HISTORIC AND DESIGN REVIEW COMMISSION

June 19, 2019

HDRC CASE NO: 2019-328
ADDRESS: 3903 N ST MARYS, San Antonio Zoo
3015 BROADWAY
LEGAL DESCRIPTION: Public Property
NCB 6298 BLK 4 LOT 145 THRU 150
ZONING: R-6, HS, C-2, RIO-1, PUBLIC PROPERTY
CITY COUNCIL DIST.: 1,2
LANDMARK: Brackenridge Park
APPLICANT: Ryan Schmidt
OWNER: ARW Kiddie Park Land, LP
TYPE OF WORK: Relocation of Kiddie Park to the San Antonio Zoo
APPLICATION RECEIVED: May 17, 2019
60-DAY REVIEW: July 16, 2019
CASE MANAGER: Edward Hall
REQUEST:

KIDDIE PARK RELOCATION TO THE SAN ANTONIO ZOO

MAIN ENTRY GATE ELEVATION

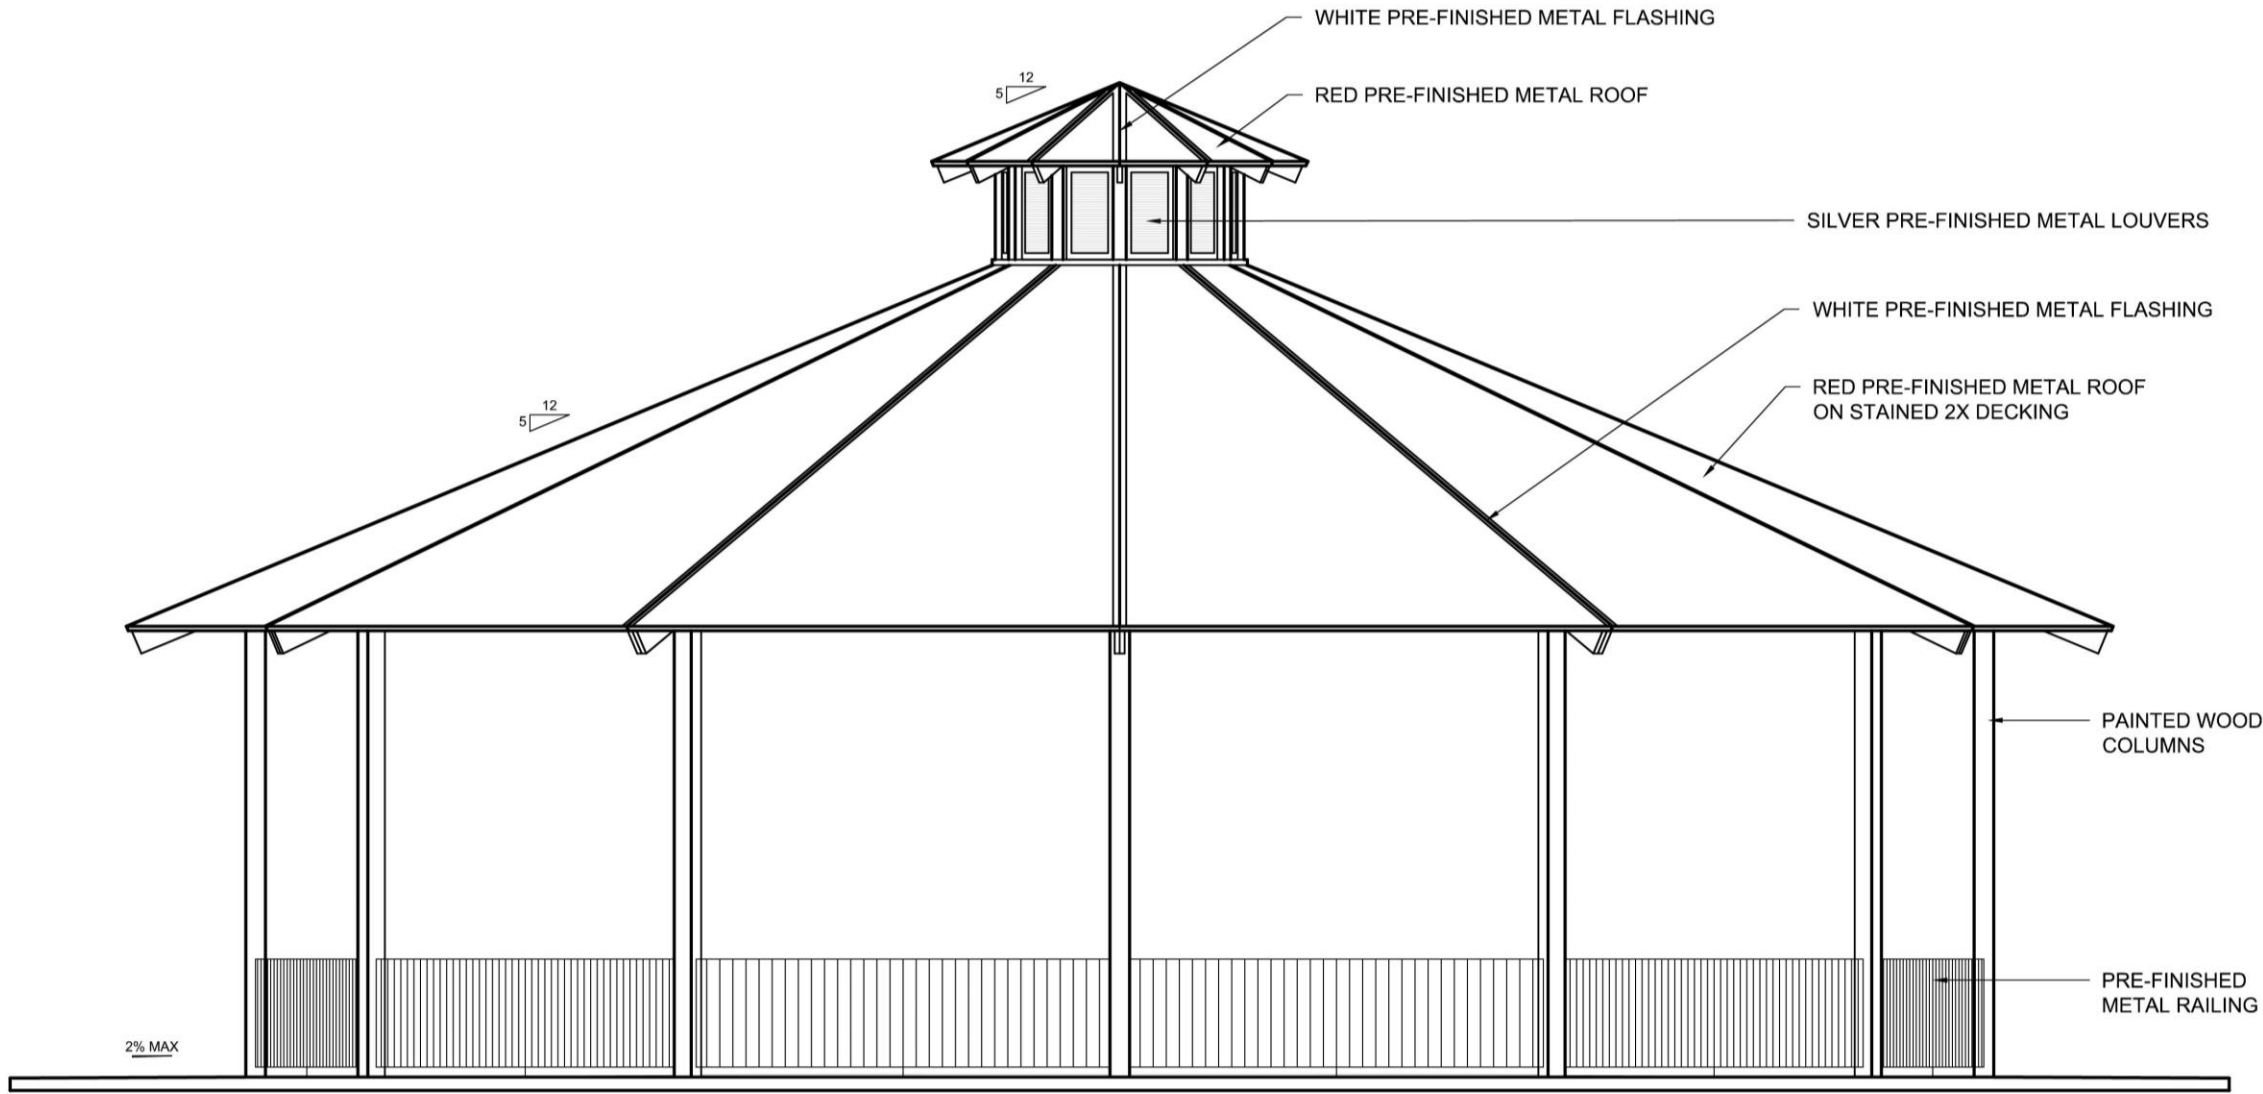
The entry gate will be recreated to match the Broadway site. Gates, arched sign, and flagpoles will be reused and look the same as before. Matching limestone will be used to recreate the bases. See drawing below and reference photo of entry gate in Part 1.
